**BROWNS FERRY NUCLEAR PLANT (BFN) - UNITS 1, 2, and 3
EMERGENCY PLAN IMPLEMENTING PROCEDURE (EPIP) REVISIONS**

TVA is submitting this notification in accordance with the requirements of 10 CFR Part 50, Appendix E, Section V, to provide NRC with the following EPIP revisions: (1) EPIP Index is canceled; (2) EPIP-1, Table of Content (TOC), Revision 30; (3) EPIP-1, Section II-4.0, Revision 29; (4) EPIP-1, Section III-4.0, Revision 29, (5) EPIP-2, Revision 22; (6) EPIP-3, Revision 25; (7) EPIP-4, Revision 24; (8) EPIP-5, Revision 29; (9) EPIP-8, Revision 13; and (10) EPIP-14, Revision 16.

ENCLOSURE
TENNESSEE VALLEY AUTHORITY
BROWNS FERRY NUCLEAR PLANT
UNITS 1, 2, AND 3

EMERGENCY PLAN IMPLEMENTING PROCEDURES (EPIP)
EPIP -1, -2, -3, -4, -5, -8, and -14

ATTACHMENT C (Page 1 of 1)
PROTECTIVE ACTION RECOMMENDATIONS

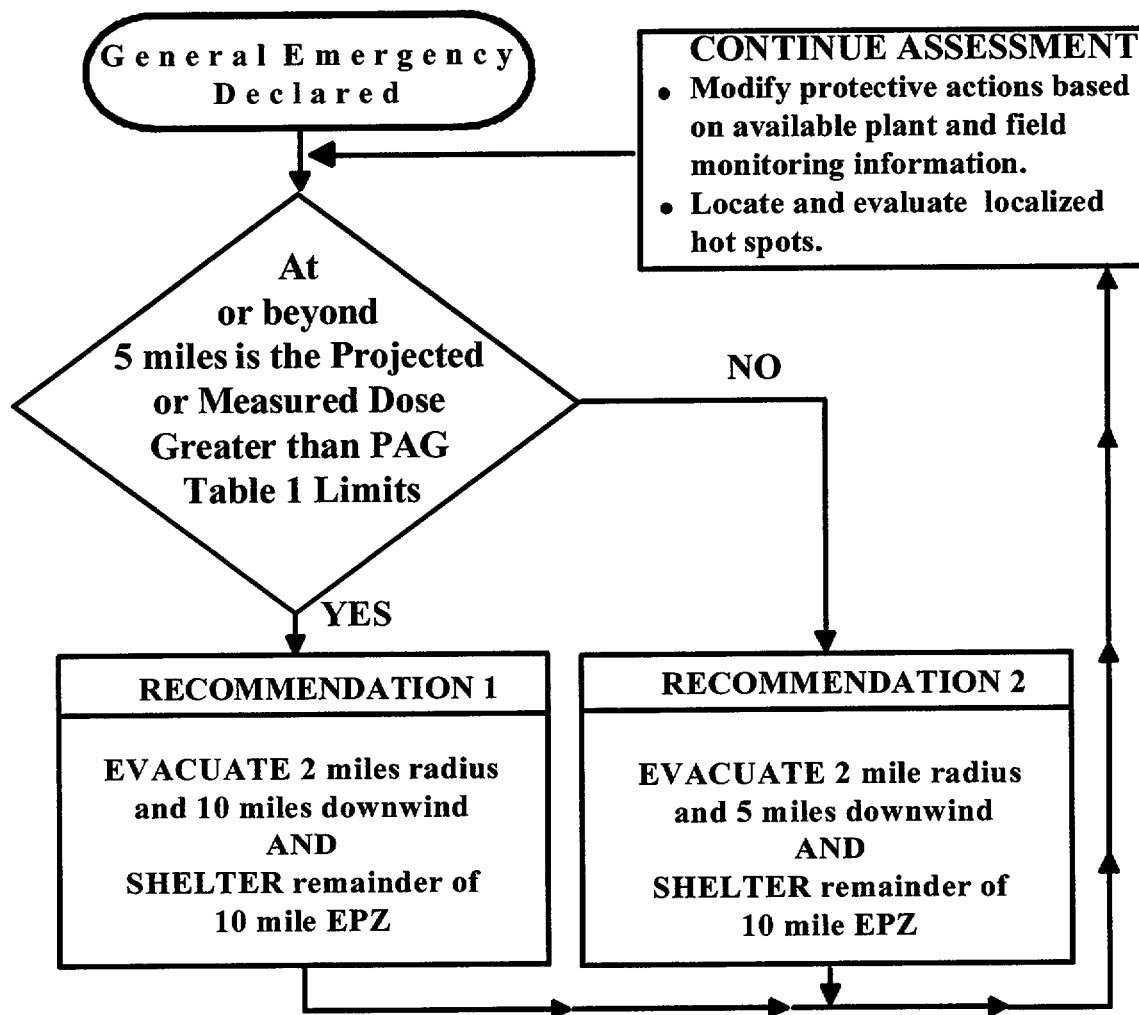
- Page 10 - revised to update information supporting Unit 1 Operator actions regarding ERO staffing support.
- Page 11 - revised Protective Action Recommendation Flowchart.
